309 KING STREET NEWCASTLE

COUNCIL RFI - SOLAR

25 JUNE 2025

CONTENTS
SOLAR ACCESS COMPLIANCE RESPONSE

2 SK SKYLIGHT 2

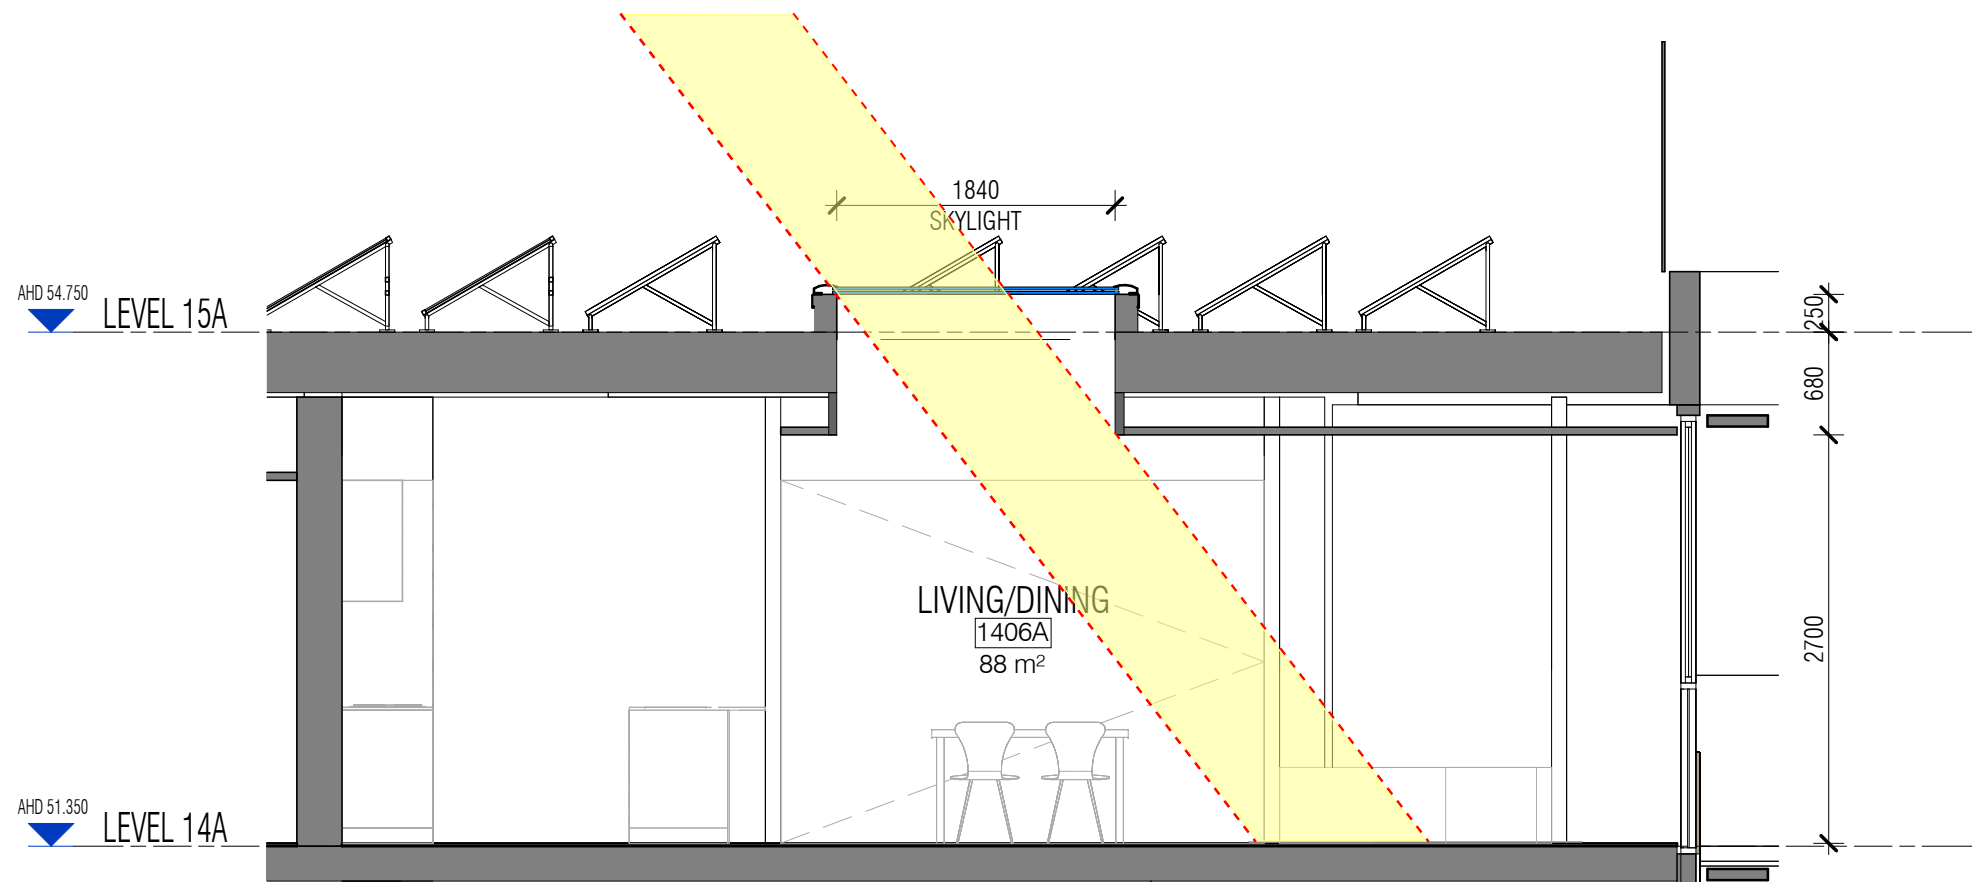
Due to solar access compliance reducing current analysis once again assumes that skylights could be used to improve the compliance percentage. The current proposal is to use a combination of skylights (2) and voids within the existing profile of the parapets (7) to bring addition sunlight into top level apartments. This has been analysed in a 3D model environment to ensure that compliant sunlight is provided

1406 - A -SKYLIGHT

1405 - A -SKYLIGHT
